SUBJECT: On-Base Groundwater, Areas of Concern - Final Remedial Design Work Plan, Final Design Drawings

1. Enclosed are replacement/insert pages for the On-Base Groundwater Areas of Concern, Final Remedial Design Work Plan previously submitted in February 2008 and the Final Design Drawings. Responses to the regulatory comments received in April 2008 are included and the comments have been addressed in the documents. The remedial work is scheduled to begin during June 2008.

**FINAL  
Design Drawings  
Former Griffiss Air Force Base  
Rome, New York**

Date:	ENGINEERING / DOCUMENT REVIEW		Document: Remedial Design Work Plan (RDWP) and 90% design Drawings
May 20, 2008	Griffiss OBGW Project		
Comment No	Reference (Page and Para)	Comment	Response
3	Nosedocks/ Apron 2 and Building 817/WSA	Figure 1-4 of the Design Drawings shows the locations of two existing horizontal air sparge barriers. The design documents and drawings do not include sufficient detail on these features which are proposed as a contingent alternative. The RDWP needs to be revised to clearly indicate whether these features already exist and what their design capabilities are. Furthermore, the RDWP needs to provide deta

Figure 2-1 Decision Process for Contingency Plan Implementation, Landfill 6 Site

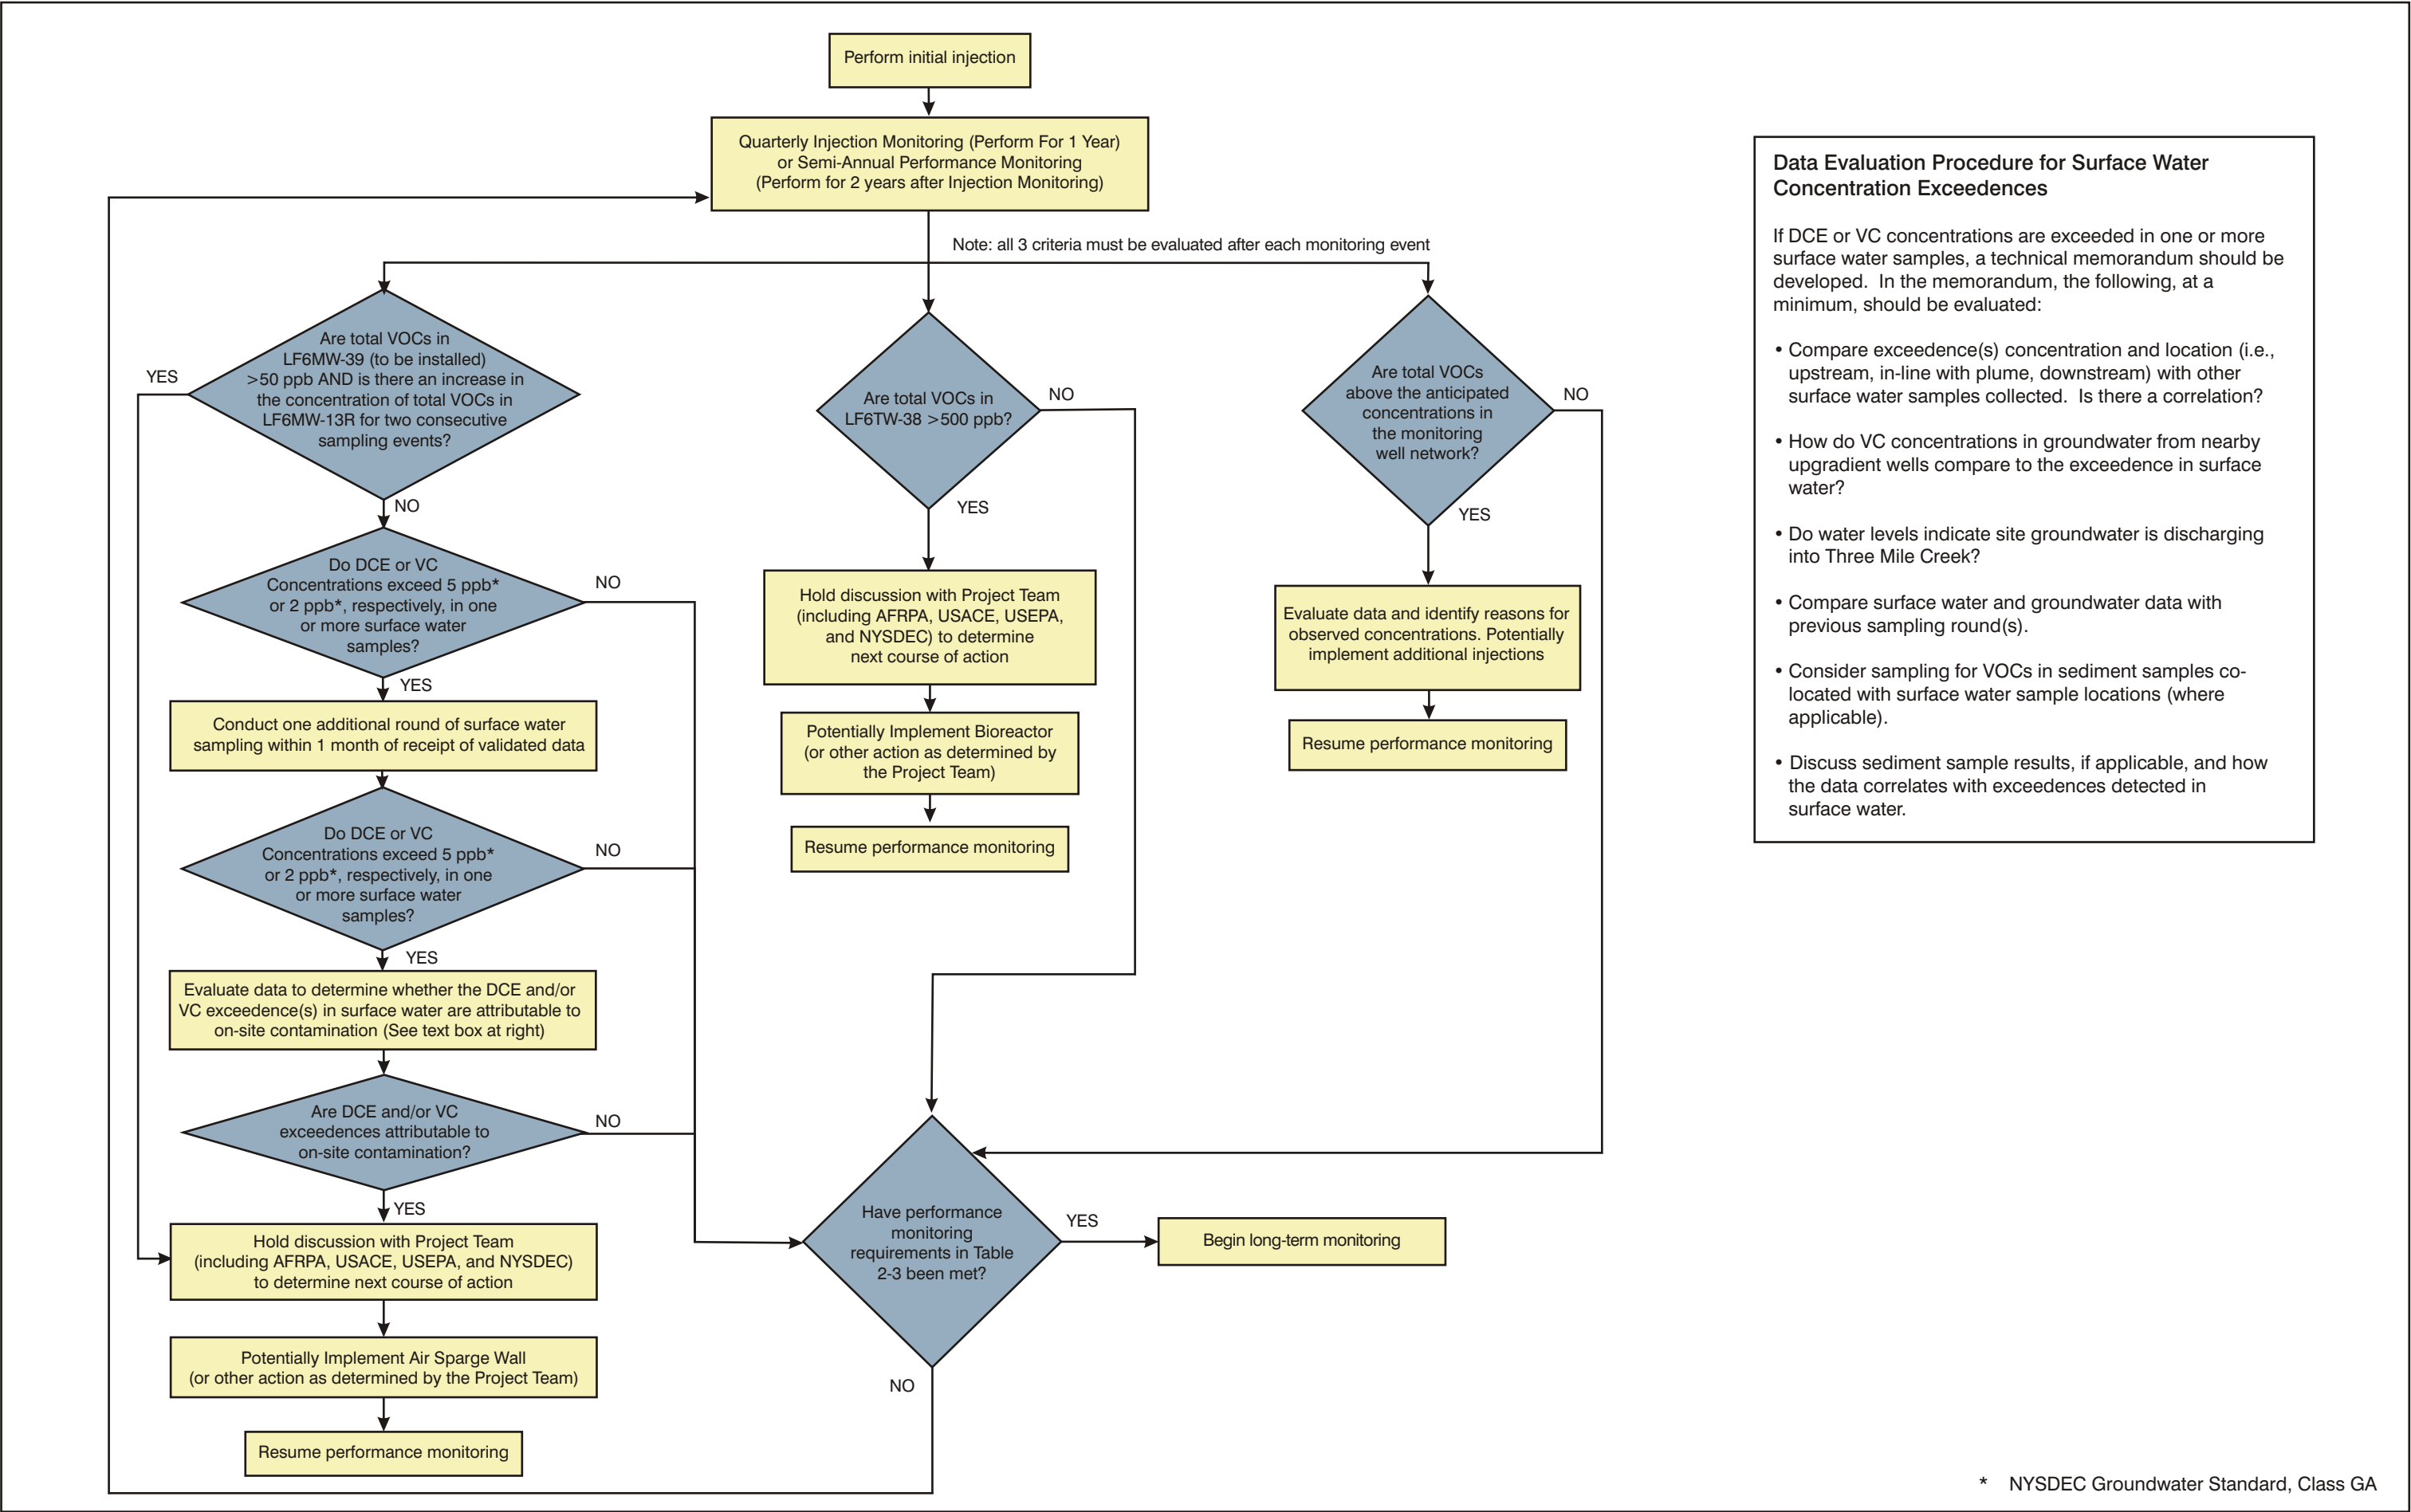
8	Figure 2-1, Decision Process for Contingency Plan Implementation, Landfill 6 Site, Pages 2-13 and 2-14	The flow path of the decision tree lists the decision criteria as “Total VOCs above the anticipated concentrations in the monitoring well network.” These values are based on a sliding scale as described in Table 2-2, Attenuation Rates of COCs at the Landfill 6 Site. Ensure that in future design submittals this information is translated into a decreasing trend table for ease of reference.	The calculated total VOC concentrations presented in Appendix A will also be presented in either graphical or tabular format in future evaluation reports associated with this site for comparison purposes with recent data collected. Text will be added to Section 2.5.1 to ensure this information is included in future reports as requested.
